**Development Application for Stage 1 Development at the Harbord Diggers Site,  
Freshwater - 2013SYE031**

The following is a summary of response to Council's 11 recommended reasons for refusal as outlined in their assessment report. These are addressed in groupings of issues and not in the numerical order as outlined in Council's report so that the logic of our proposal can be simplified in its response.

**Image 2**

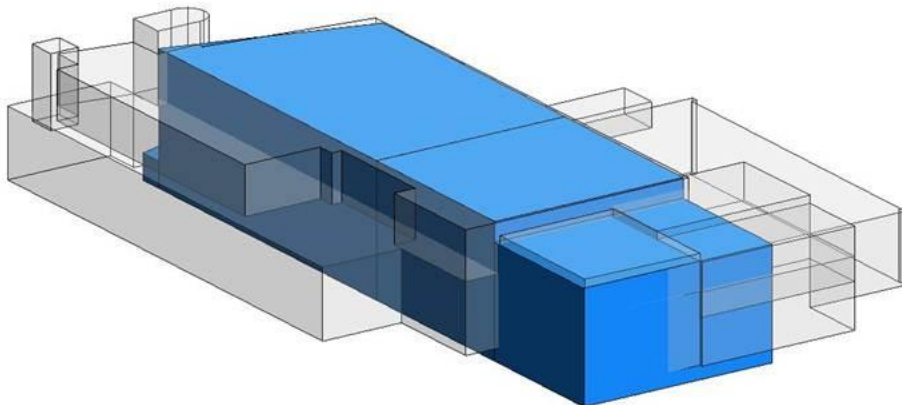
- Council's assessment of Building D indicates that in their opinion Building D does not comply with the height standards of the SEPP (HSPD) and the Warringah LEP. Council's assessment however fails to acknowledge the Clubs right to height and the significant improvements (reduction of bulk by 63%) to this building envelope.

- The following image demonstrates the proposal does not exceed the existing buildings current height, and shows the significant reduction in built form of Building D.

**Existing Building D Volume (grey): 49 044m<sup>3</sup>  
18 115m<sup>3</sup>**

**Proposed Building D Volume (blue):**
